REMARKS

In the outstanding official action of November 4, 2002, the examiner has objected to the drawings, objected to claims 8, 10 through 18, 26 through 28 and 32, rejected claims 1 through 10, 19 through 25 and 29 through 37 under 35 U.S.C. §112, rejected claims 1, 2, 19, 20, 30 and 34 under 35 U.S.C. § 102(e) and rejected claims 3 through 10, 21 through 25, 29 and 35 through 37 under 35 U.S.C. § 103(a). Applicants respectfully traverse the stated objections and rejections and submit that in view of the foregoing amendments and the following remarks, this application is now in condition for allowance.

MARKED-UP SET OF AMENDED CLAIMS:

FIG. 1

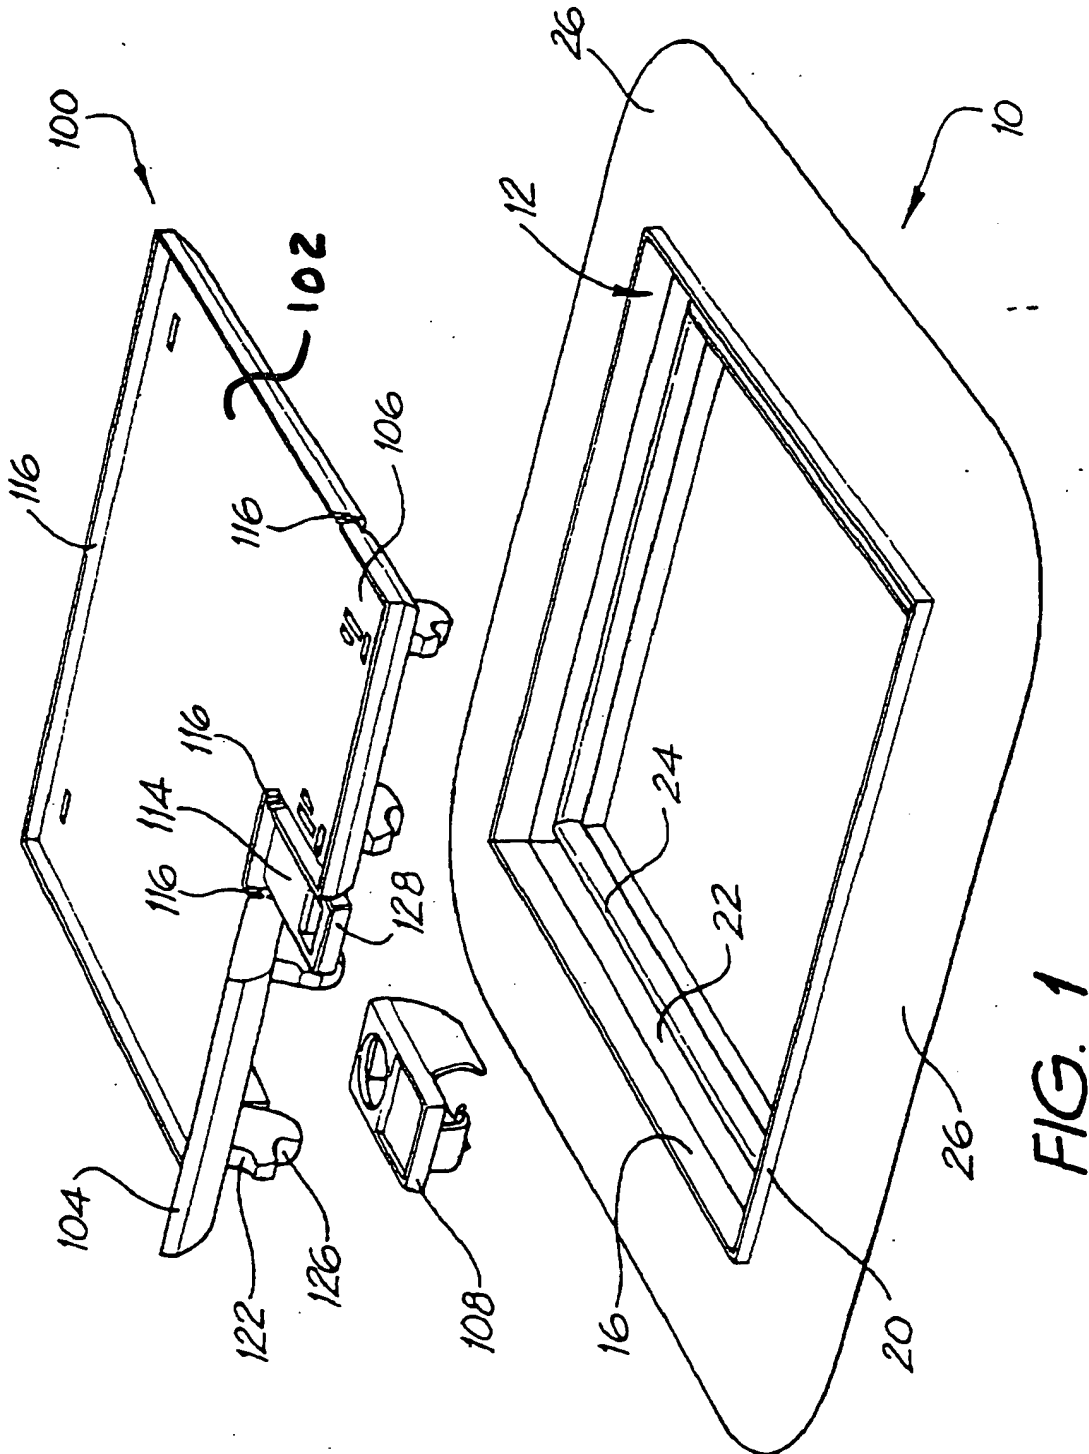
With regard to the objection to the drawings, a marked-up copy of Figure 1 showing an appropriate proposed correction in red adding the reference numeral 102 is attached. In addition, marked-up copies of Figures 2a and 3 are attached showing proposed corrections in

red to correct a couple of minor typographical errors and omissions. It is respectfully requested that the examiner approve the corrections shown in red on the attached marked-up copies.
